**Almonaster/Larriviere Sewer Extension
For the City of Youngsville, LA**

ADDENDUM NO. 1

MAY 2020

**RISERS/SADDLES FOR BORED SEWERS
>6' DEEP (SERVICES 10:00-2:00)**

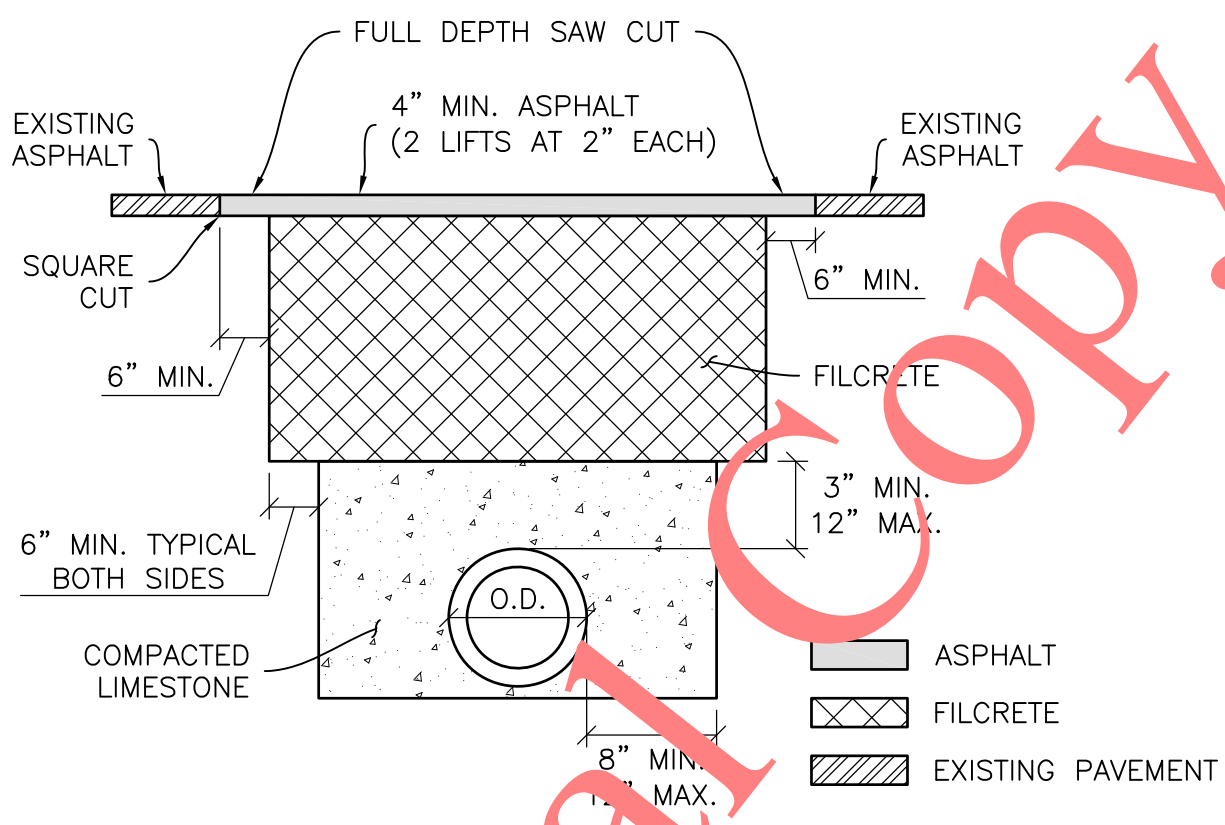
- Item No. 3** REFER to the Plans for the Project and the Specifications, Section 02730 – Sanitary Sewer (Gravity). The contractor will be allowed to install the gravity sewer pipe by boring in lieu of open cut installation if they choose to do so. The pipe may be Certainteed Certalok pipe DR 25 or thicker, or Fusible C900 PVC pipe DR 25 or thicker. The thickness of the pipe must be coordinated with the pipe manufacturer relative to pull forces; should thicker pipe be recommended by the pipe manufacturer, the thicker pipe shall be provided and the cost for the thicker pipe included in the contract unit price. The contractor shall be responsible for achieving the correct grade of the pipe, and to correct any defects in grade, etc., at no cost to the Owner. The contractor shall be required to connect to each manhole with flexible connectors (e.g. Kor-N-Seal boots) as per the plans and specifications. Manholes shall conform to the contract requirements. Any couplings, materials, etc. required to install the manhole as per the details shall be included at no direct pay. Should this alternative be chosen by the contractor, the contractor shall not be paid for special backfill, embedment, surface restoration, etc. since such work will not be performed if bored. The pipe installed by this method shall be paid at the unit price for “Furnish & Install 8” Gravity Sewer” at the depth of as indicated in the contract bid form for the appropriate depth. Payment at the unit price shall constitute full payment for all materials, labor, excavation, backfill, bore pits, mud pits, etc. The length paid shall be from center of manhole to center of manhole only (no payment for excess pipe pulled in the bore). If the contractor chooses to use this method of construction, he may use a stainless steel saddle for the service risers, as depicted in the detail included in this addendum. There shall be no additional pay for this item; it shall be paid as a service riser, and payment shall include all materials including but not limited to limestone encasement, clamps, etc. Limestone will not be measured for separate payment; it shall be included in the unit price for the service riser. The hole for the service shall be cut with a hole saw and shall be smooth, round, and without defects of any kind.

SPECIAL PROVISIONS FOR
SERVICE RISERS ON BORED SEWER LINES

1. CLAMPS FOR SEWER PIPE SHALL BE ROMAC INDUSTRIES STAINLESS STEEL, "SS1-H", "SS2-H" OR "SS3-H", (O.A.E.). MIN. 18" WIDTH FOR 8" SEWERS, 30" MIN. WIDTH FOR LARGER SEWERS.
2. FULL CIRCLE, FULL WIDTH GASKET SHALL BE USED FOR SADDLE, SBR PER ASTM D 2000 MAA 610, COMPOUNDED FOR WATER AND SEWER SERVICE.
3. BRANCH TO NECK CONNECTION SHALL BE MADE WITH ROMAC SS1-H REPAIR CLAMP.
